SYDNEY CENTRAL PLANNING PANEL

JRPP No	2017SCL015 DA
DA Number	DA 14/207/03
Local Government Area	Bayside Council
Proposed Development	Modification Application to modify Development Consent No. DA-14/207, which was determined by the Sydney East Joint Regional Planning Panel, by enclosing the undercroft area to create a 30 place childcare centre at ground level, enclosing the balconies across Levels 1 – 6 to create a second bedroom, enclosing the open terraces across Levels 1 – 6 to create an additional studio, incorporating 2 penthouse apartments on Level 7, providing 12 additional car parking spaces in the basement and several internal modifications to the loading area, office and plant rooms of the approved commercial building.
Street Address	53-79 Baxter Road & 67-79 Baxter Road, 62-66 Robey Street, Mascot
Applicant	Zauner Construction
Owner	Regional Express Holdings Ltd, Greatland Development Pty Ltd, & B W Davies Pty Ltd

panel's consideration	
Report by	Kim Johnston/Brendon Clendenning – Senior Development Assessment Officer

Figure 14: Proposed Ground Floor Plan - enclosure of the western and western ends
 (Source: Clark Keller, dwp Suters, December, 2016)

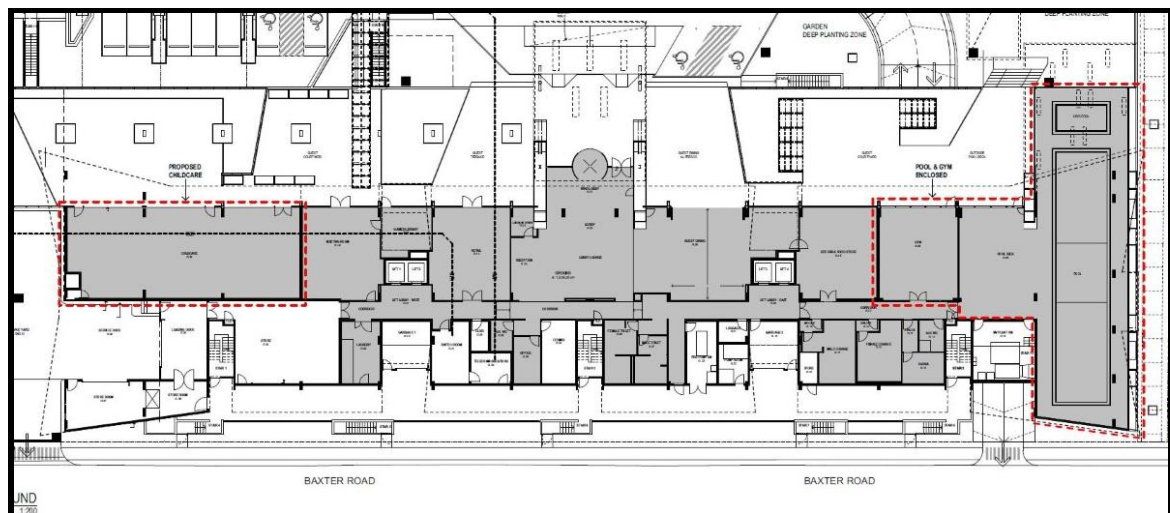
Reasons given for the justification of the non-compliance include that the proposal does not result in any change in the overall height, bulk and scale compared to the approved development and that the proposed additional floor space is largely contained within the approved building footprint. The same concerns which were raised with the original proposal are held in this regard, being that the resulting bulk and scale of the proposed additional GFA is unsatisfactory and will result in an unacceptable built form.

The FSR matter is considered in detail above and was found to be unsatisfactory. While the effect of the proposed additional floor space is greater at the upper levels, there are still adverse impacts of bulk and scale at the ground floor. The open areas on the ground floor assist with reducing the bulk and scale of the building when viewed from the street. Accordingly, the additional floor space proposed, which was to comprise a future child care centre, is not supported.

Figure 15: Proposed Level 1 Plan - enclosure of balconies at the eastern and western ends of the approved building (Source: Clark Keller, dwp Suters, December, 2016)

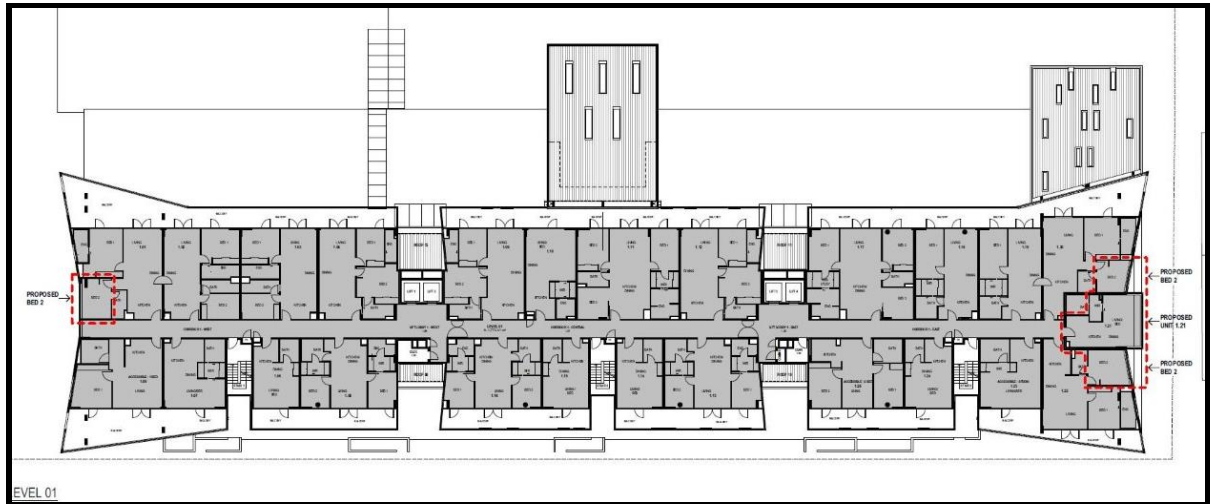
The departing floor space results in an adverse visual impact due to the resulting excessive bulk and scale and is not supported. Such impacts are greatest for the proposed penthouse apartments, however, is equally inappropriate to enclose the balconies/terraces at the eastern and western ends of the building given these areas provide relief in the massing of the building.

Figure 16: Proposed Penthouses -Level 7 (Source: (Source: Clark Keller, dwp Suters, December, 2016)

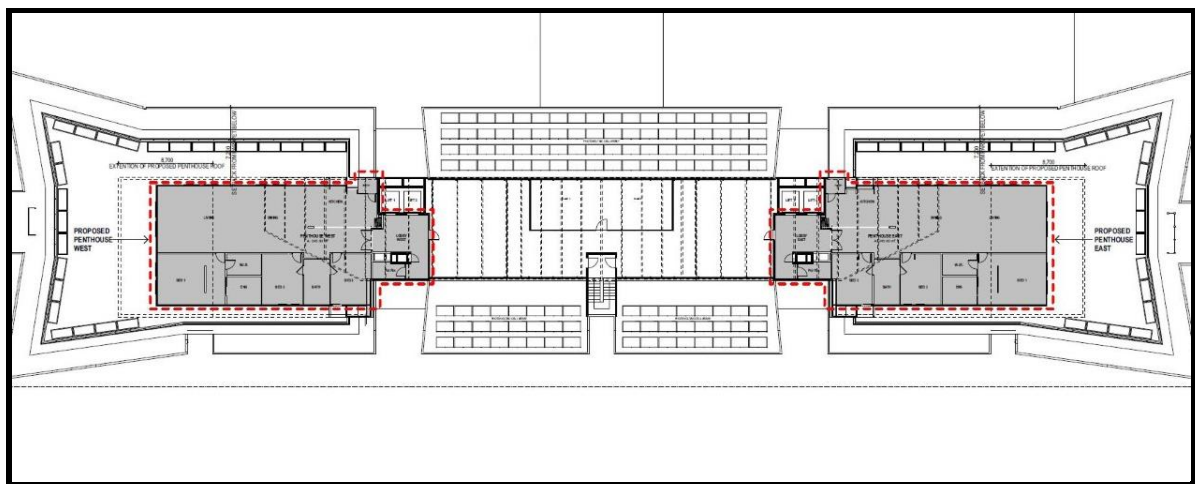
These reasons are not supported as it is considered that the proposed additional floor space at the rooftop due to the proposed modification will have a detrimental impact on the surrounding properties and the public domain as a result consequence of the increased bulk and scale which will result from the additional floor space at this location.

Figure 22: Proposed North East Perspective without balconies and terraces (Source: Clark Keller, dwp Suters, December, 2016)

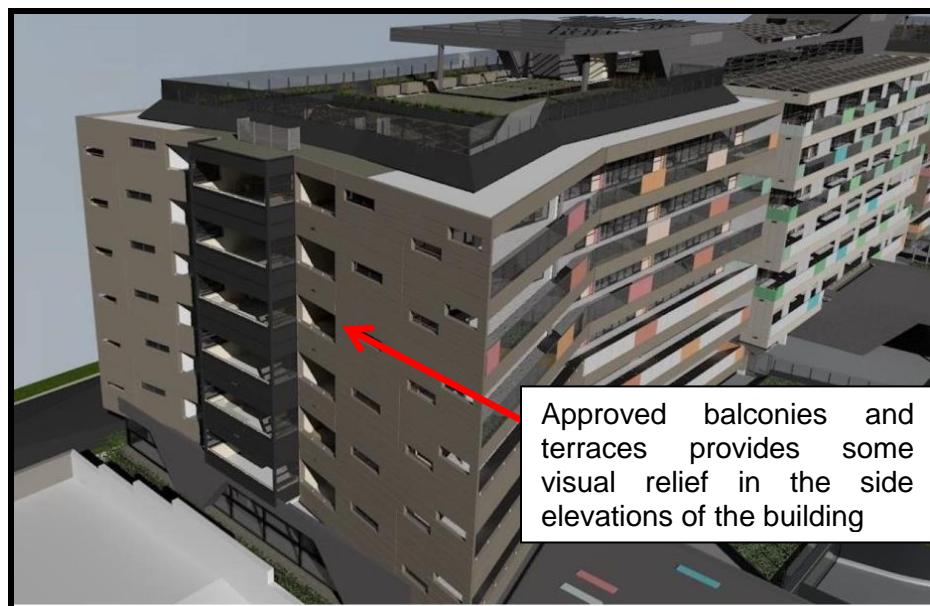
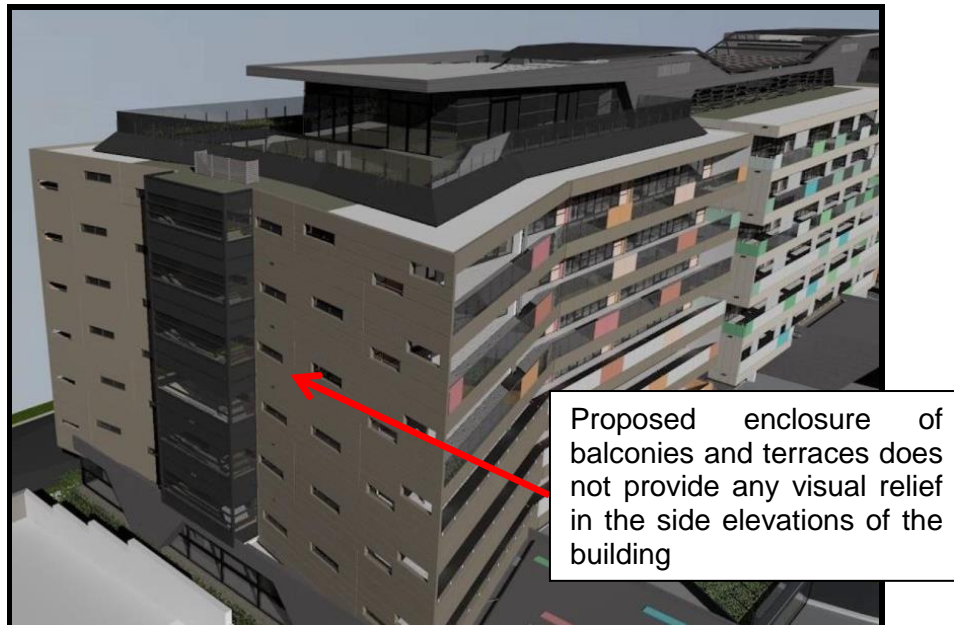
- There is likely to be an adverse visual impact for the adjoining residential properties and the public domain due to the excessive bulk and scale proposed in this modification. The proposed additional FSR will be visible from various public and private vantage points, including John Curtin Reserve and the streetscapes of Robey Street and Baxter Road (refer to Figures 17 & 18).

- This adverse visual impact on the streetscape and surrounding properties and the public domain is likely to reduce the enjoyment of these properties due to the excessive bulk and scale of the proposed modification.

Figure 23: Proposed northern elevation (Source: Clark Keller, dwp Suters, December, 2016)

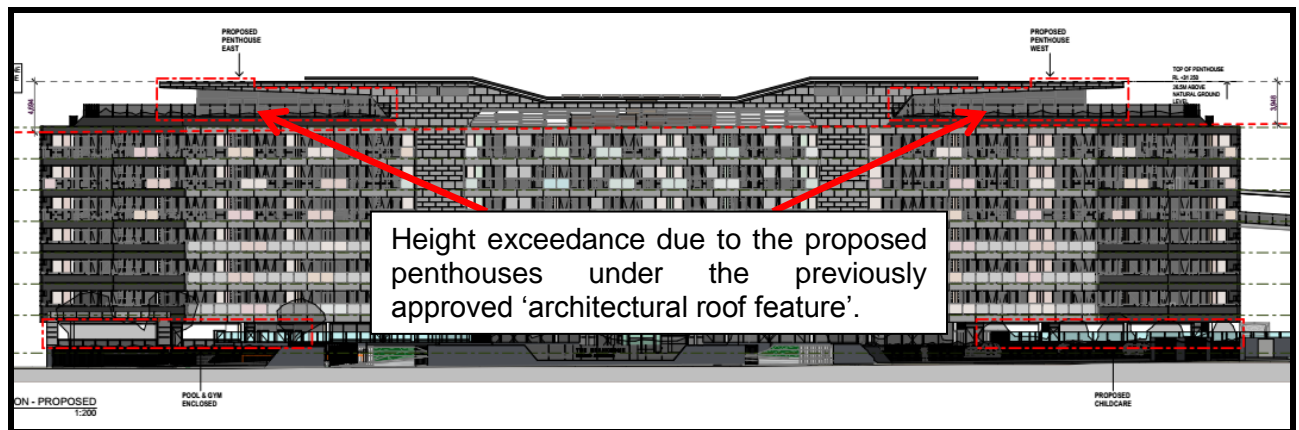
The proposed modification seeks to reintroduce the elements that were earlier deleted to achieve compliance with the panel's direction, including the originally proposed penthouses which were removed prior to consideration by the JRPP, and thus the overall non-compliance is now proposed to be 4.78 metres above the maximum height limit.

This height exceedance has increased from 638mm to 4.78 metres as the area of the building above this height no longer satisfies the criteria, pursuant to Clause 5.6 of the BBLEP 2013, to be considered an architectural roof feature. This criteria requires that the architectural roof feature *does not include floor space area and is not reasonably capable of modification to include floor space area* (CI 5.6(3)(a)(iii) of BBLEP 2013).

This proposed modification seeks a maximum height of 26.78 metres, which exceeds the maximum height development standard by 4.78 metres (21% variation).

Figure 25: Proposed Roof Plan (Source: Clark Keller, dwp Suters, December, 2016)

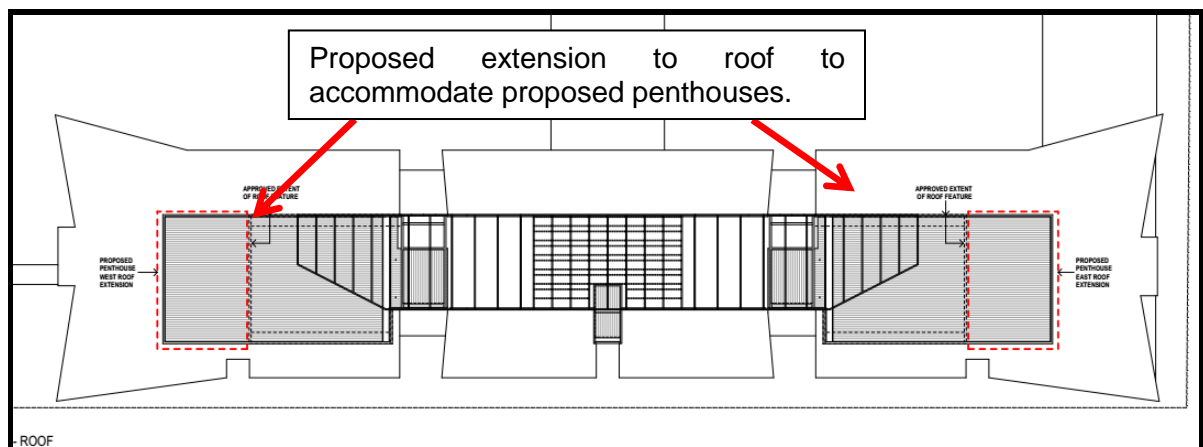
As outlined above, the proposed additional height results from the proposed inclusion of penthouses below the existing roof line in this modification application. The approved roof feature is also proposed to be extended 8.5 metres in both an eastern and western direction to accommodate the proposed penthouse apartments.

Figure 28: Western elevation

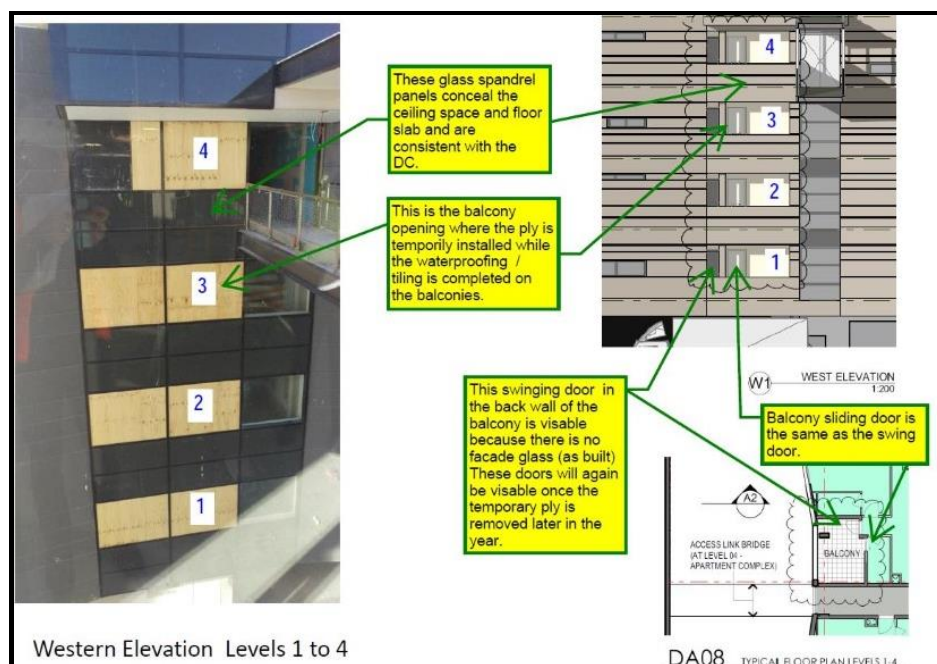
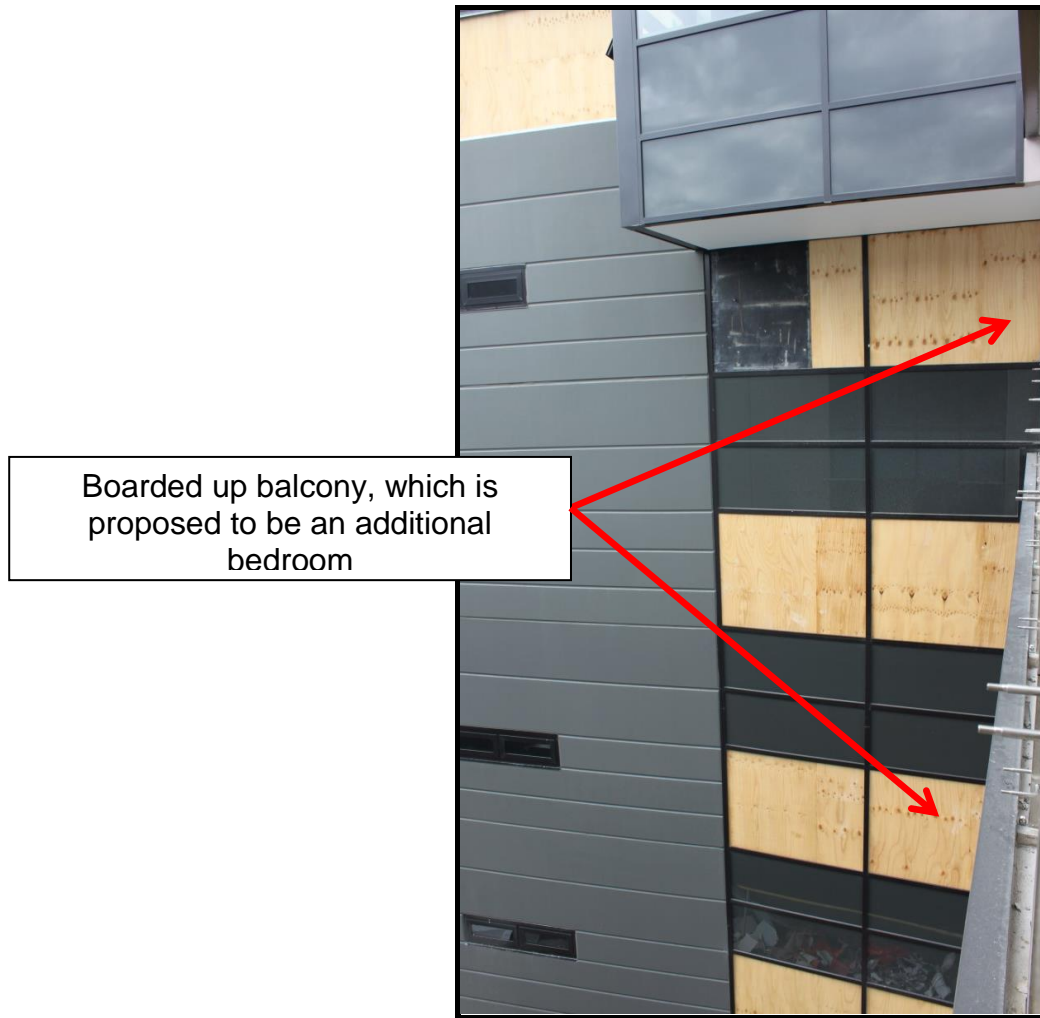
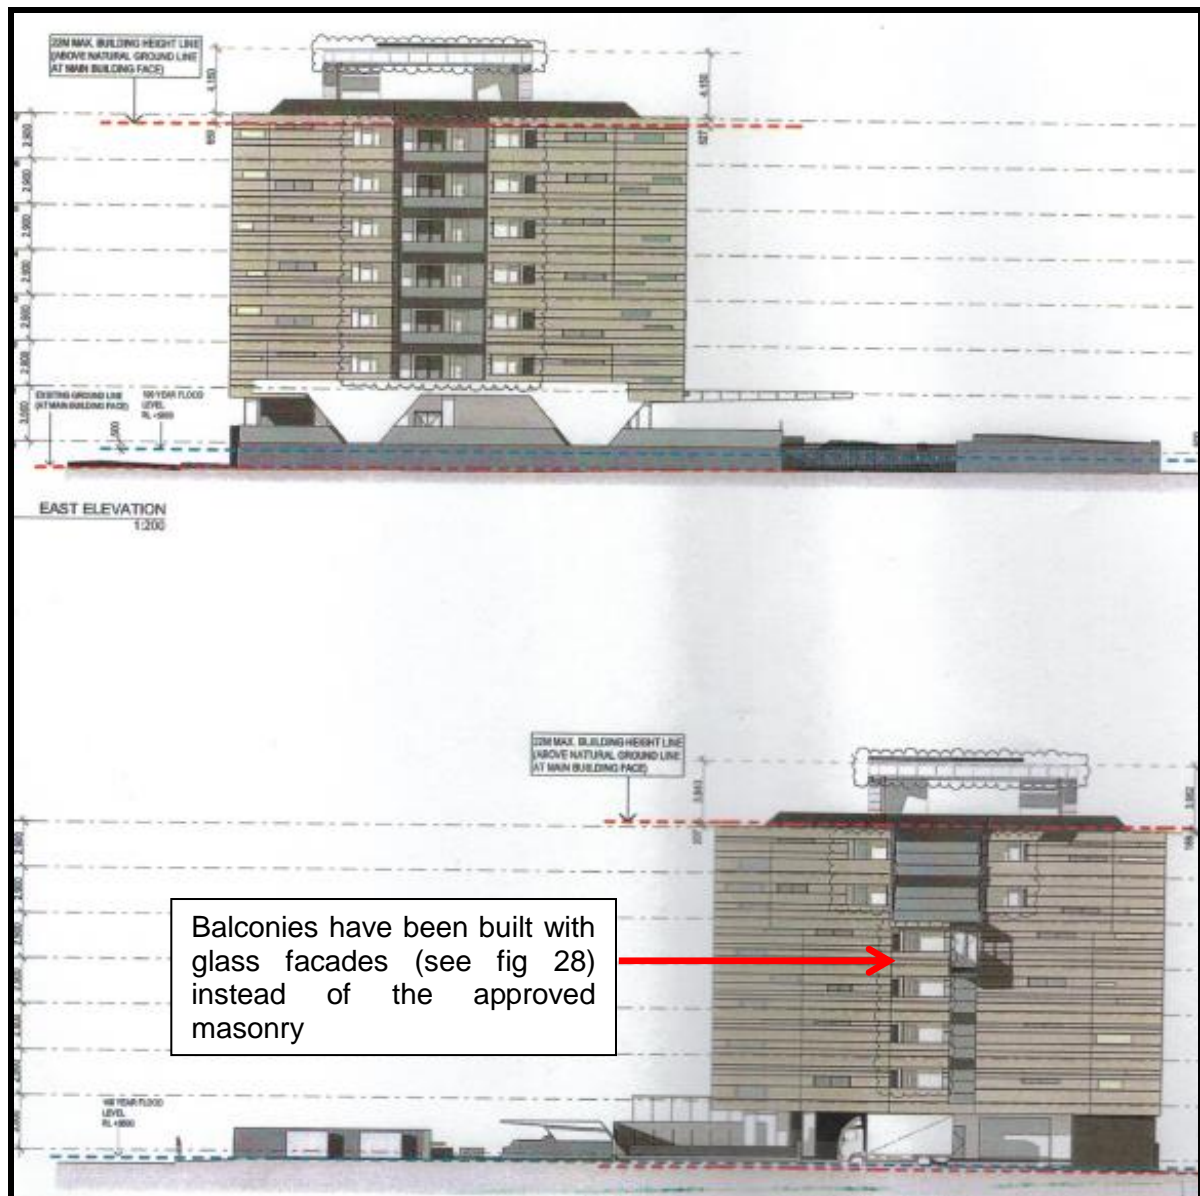
A review of the site for the assessment of this proposed modification revealed that some of the works proposed by this modification may have already been completed. In particular, there were concerns with the balconies and terraces on the eastern and western elevations, which did not appear to have been constructed in accordance with the development consent.

While the building is generally being built in accordance with the approval, it is noted that the construction of the communal sun terraces on the eastern elevation and the balconies on both the eastern and western elevations have been constructed in such a way, that they can be easily converted to their use as proposed in this modification application.
